ADDENDUM DATE: December 14, 2023

ADDENDUM NO. 4

Cobblestone Manor
1050 Lamplighter Drive
Grove City, Ohio 43123

Addendum No. 4 to the Drawings and Project Manual, dated June 8, 2023, Cobblestone Manor as prepared by Moody Nolan, Inc., 300 Spruce St. Suite 300, Columbus, OH 43215.

DRAWING TITLE:
**ENLARGED PLANS -
ELECTRICAL TYPE AS**

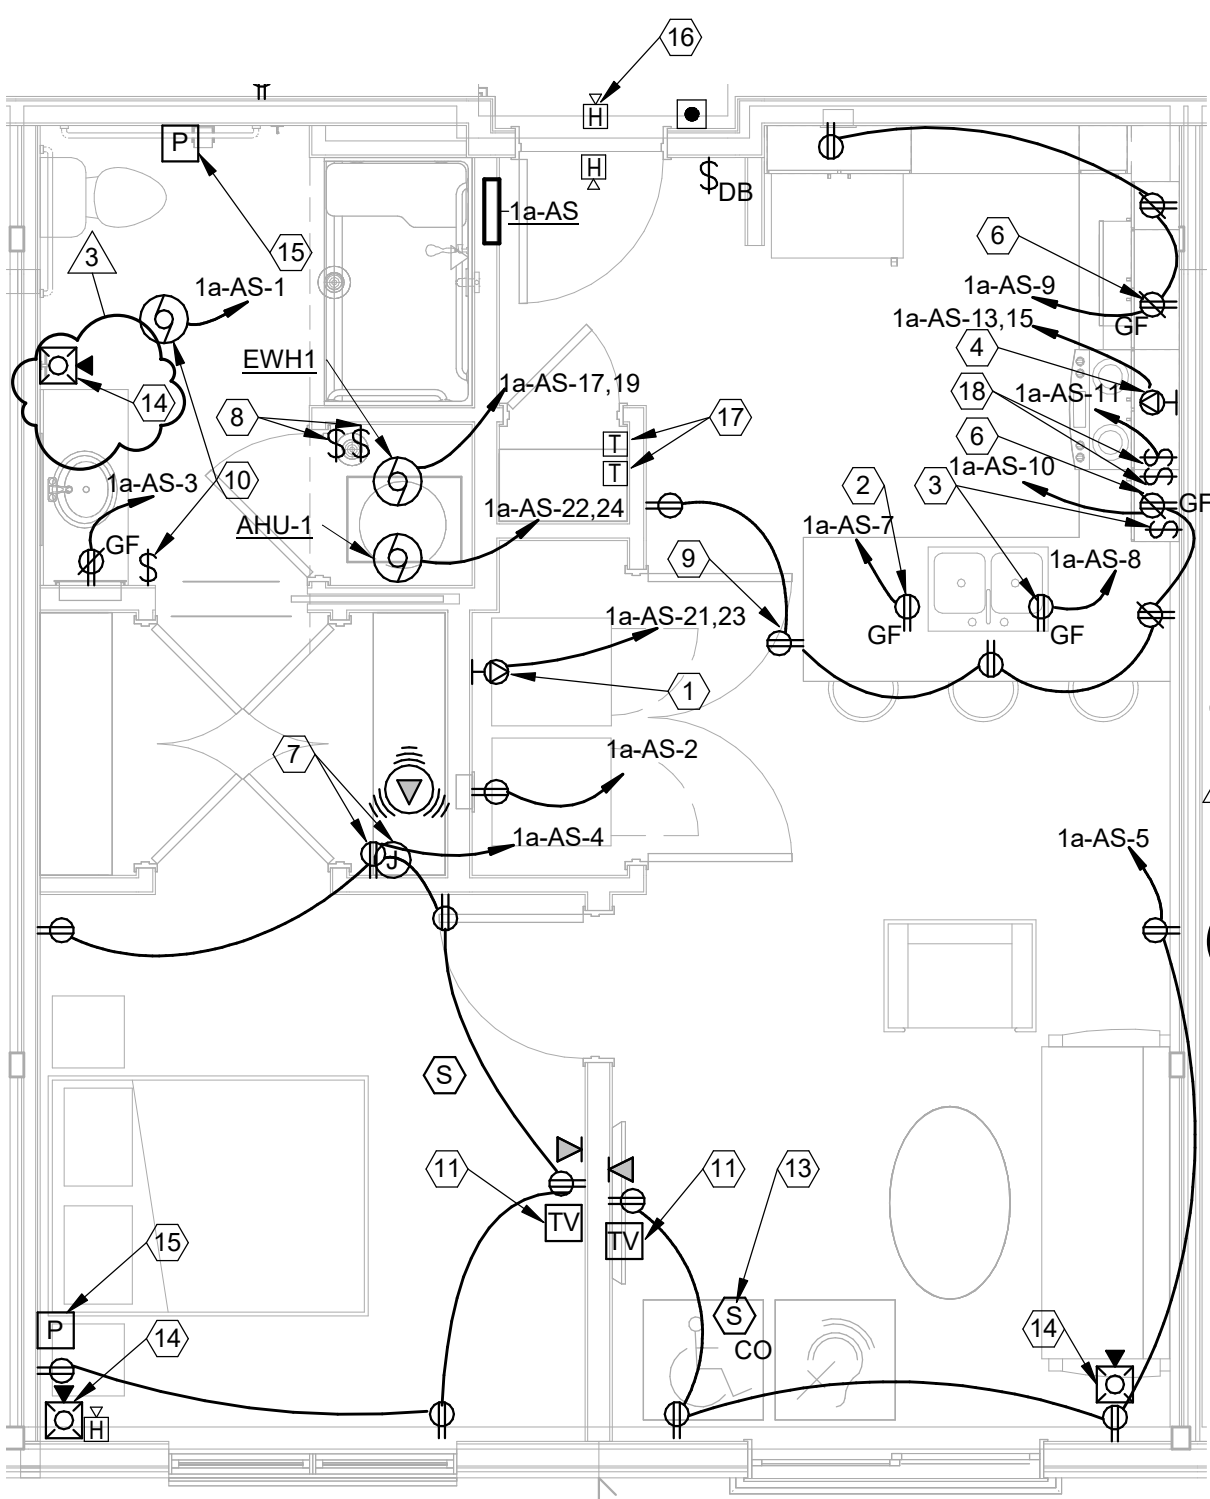
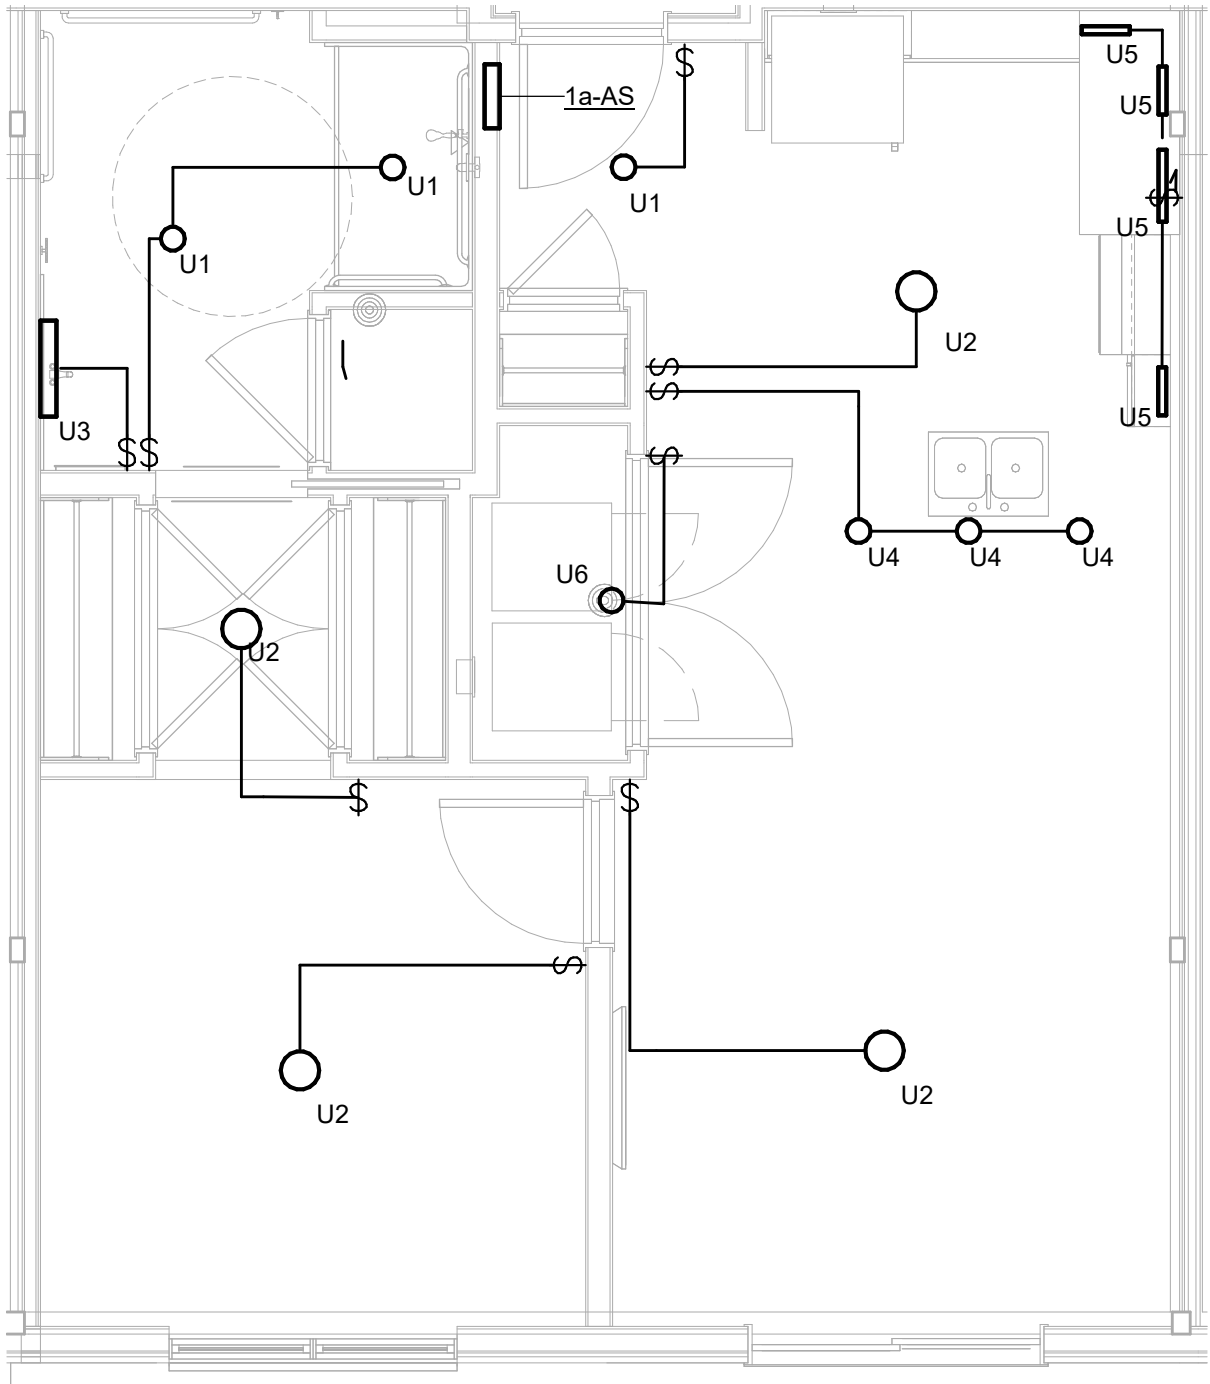
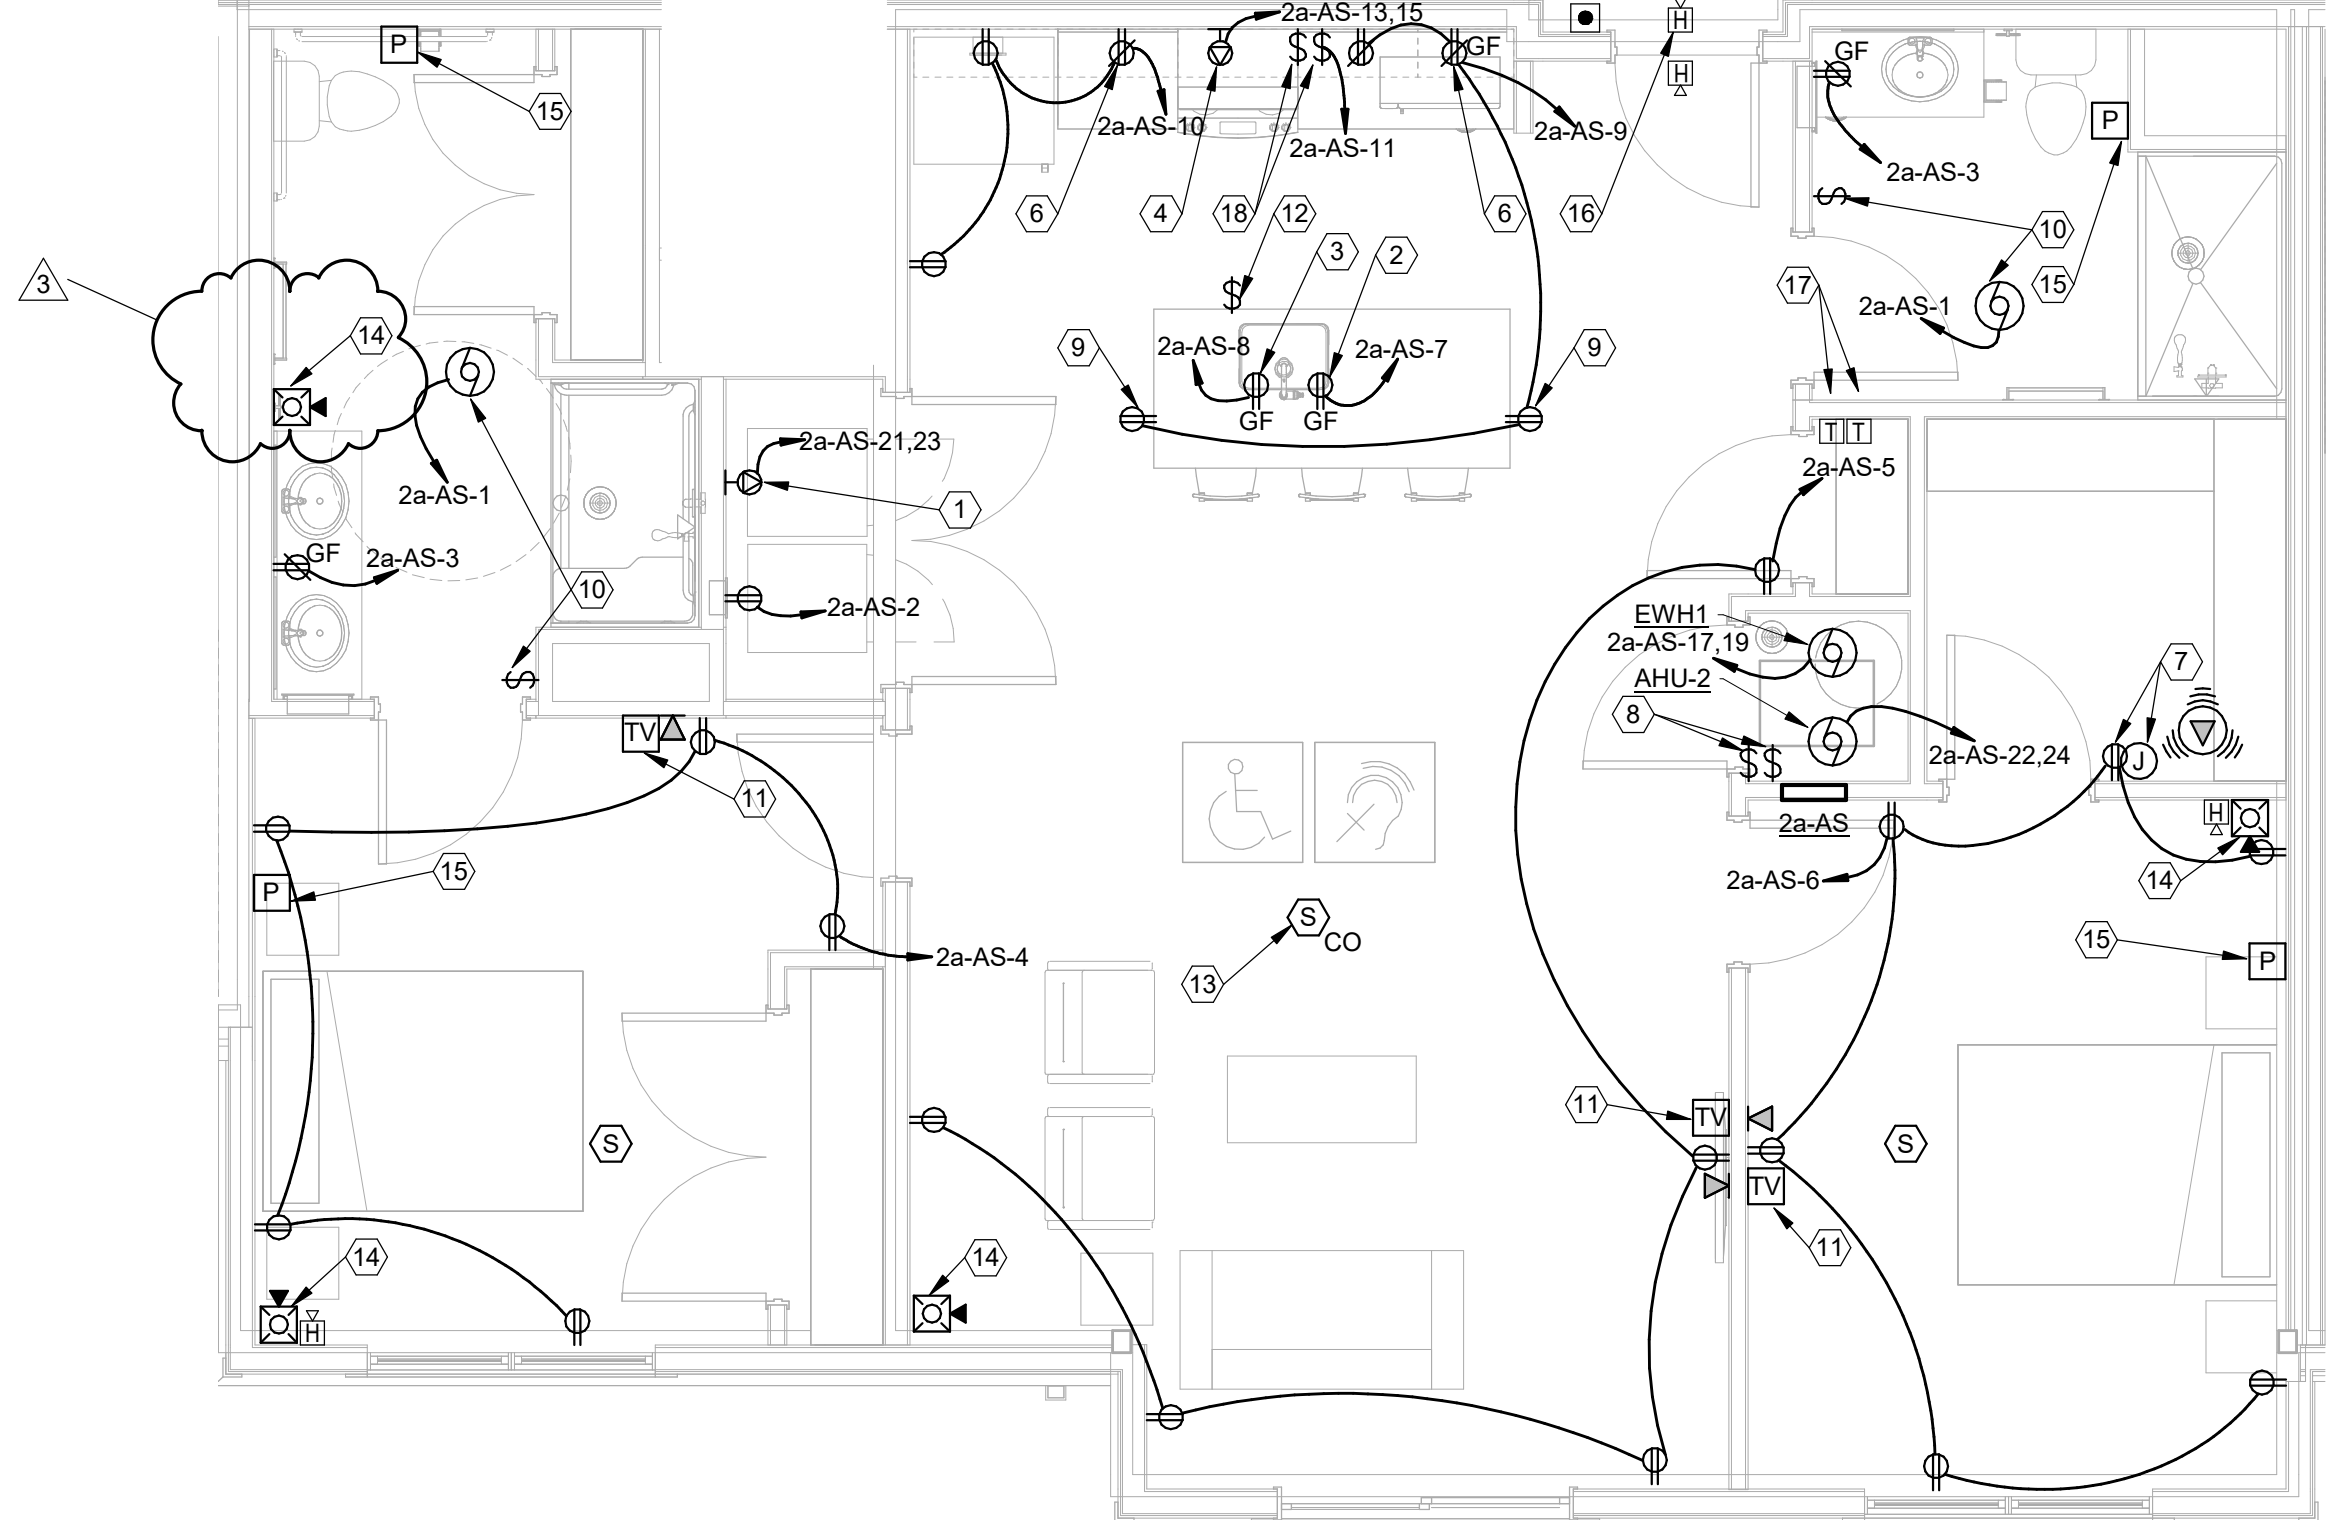
f. E403 – ENLARGED PLANS – ELECTRICAL TYPE AS

1. **DELETE** general notes M and O.
2. **ADD** low frequency fire alarm devices to unit bathrooms.
3. **ADD** RG6 and CAT6 cables from each residential unit structured media cabinet back to local demark, keynote 7.
4. **REVISE** General Note P to read as follows:
 - a. RESIDENTIAL UNIT SMOKE DETECTORS SHALL BE SYSTEM TYPE AND SHALL BE INTERCONNECTED IN SUCH A MANNER THAT
